COMMUNITY DEVELOPMENT DEPARTMENT

April 26, 2024

Re: Development Review Permit, Planned Community Permit, Heritage Tree Removal Permit, Vesting Tentative Map
1500 N. Shoreline Blvd.
PL-2023-128 & PL-2023-129

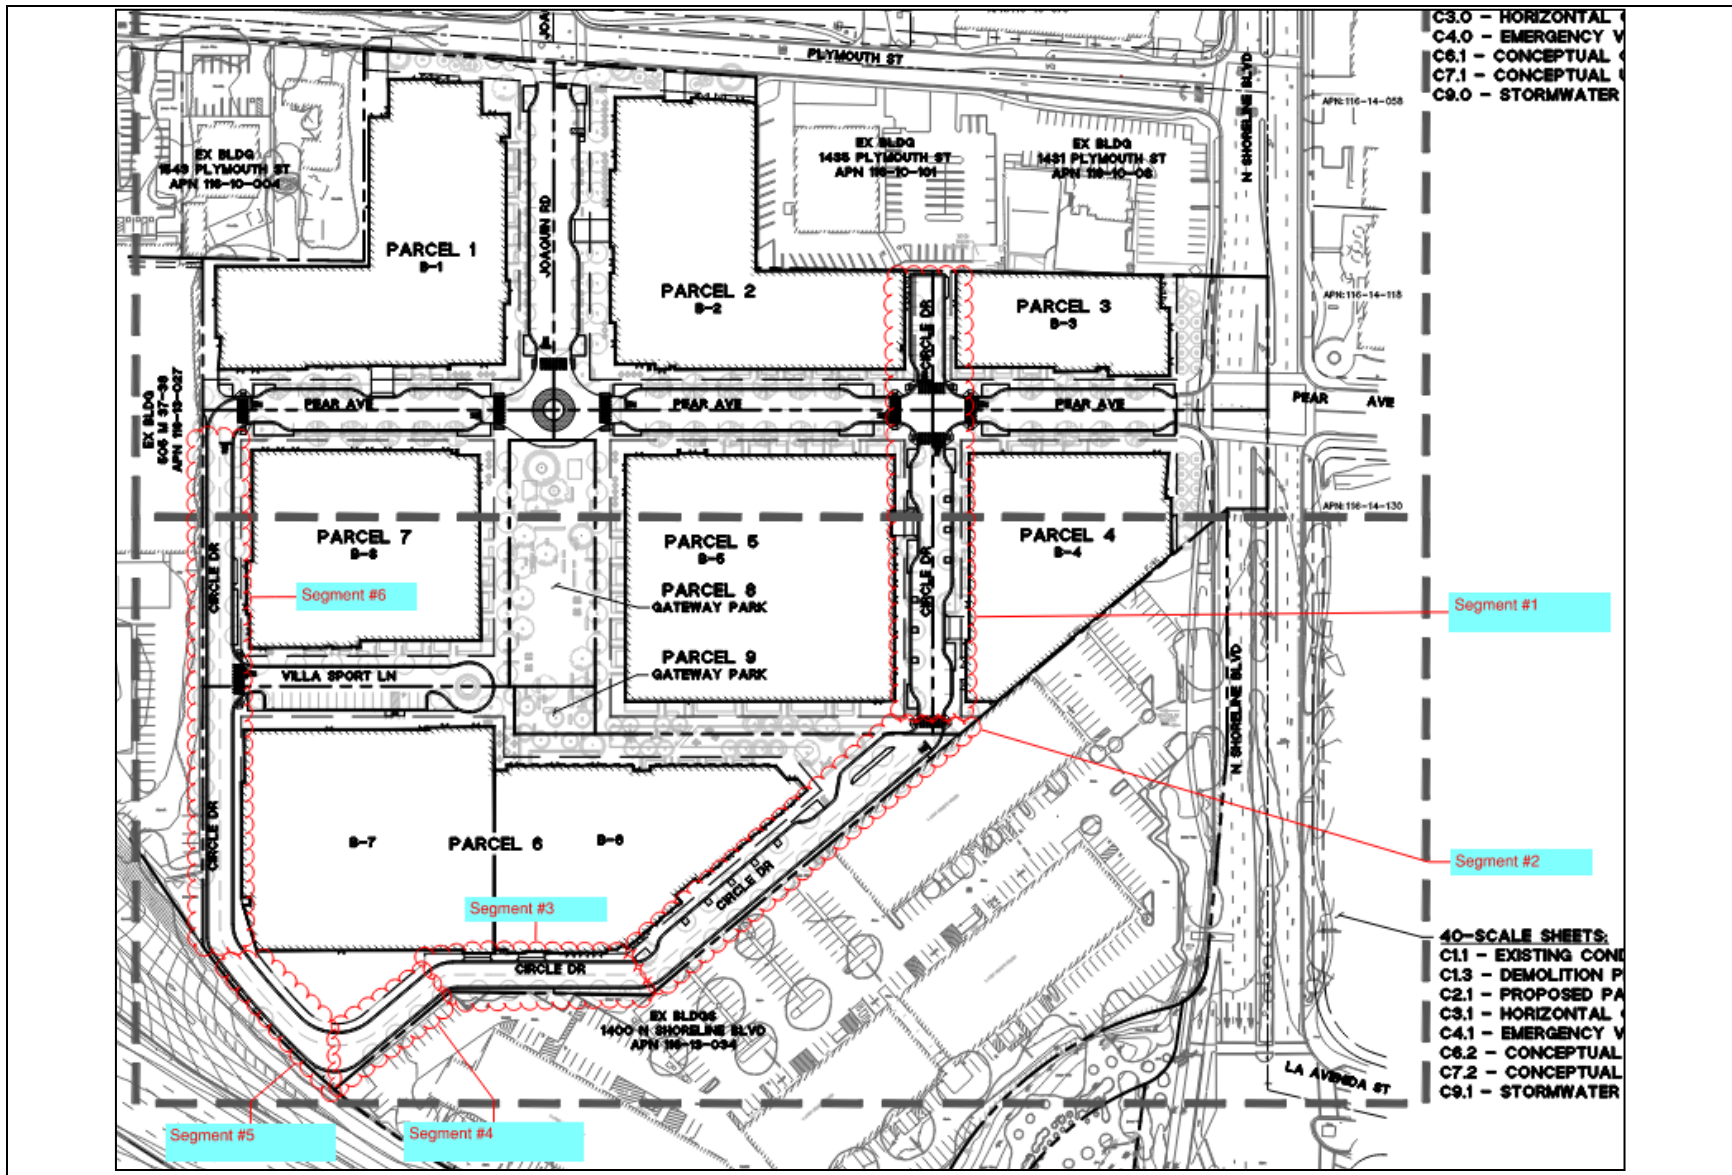
Street Network/ Alignment Comments:

Current submittal includes proposed open space (Gateway Park) with no vehicular access.

- 1) Circle Dr shall have same street configuration as Joaquin Road per GMP due to function of the street.
 - a) Circle Dr will carry more traffic due to the proposed open space and lack of direct access to south parcel. This includes adding more traffic on Main Street (Circle Dr between Parcel 4 and 5, Parcel 2 and 3), which was seen as a vibrant high density mixed use neighborhood with ground floor retail and restaurants.
 - b) Will require additional right-of-way on Pear, between Shoreline and Main Street (Circle Dr between Parcel 4 and 5, Parcel 2 and 3), for left turn pocket or left turn lane to accommodate added traffic volume.
- 2) Break Parcel 6 (B-6 & B-7) to allow pedestrian and bike access per NBMP and GMP.

<p>Alternate Option: Demonstrate the proposed street network/alignment will respect the vision and goals of the NBPP to provide a safe and complete circulation system for bikes, pedestrians, passenger vehicles, and service vehicles. If alternative street network / alignment is proposed, applicant will be required to provide funding for a transportation study to determine the adequacy of the proposal.</p>				
A8.	Street Typology	The private streets designation conflict with the Gateway Master Plan. Street dedication authorized under the Subdivision Map Act Sec. 66475.	All new streets are identified as private streets in the proposed tentative map.	Not Compliant. The project does not comply with street typology required per the GMP and NBPP. Public Streets are required to provide multimodal connectivity and utility purposes. The streets must accommodate all modes including pedestrian, bicyclists, passenger vehicles and delivery vehicles. To accommodate the required city sewer network, public street connecting 101 and Plymouth is required.
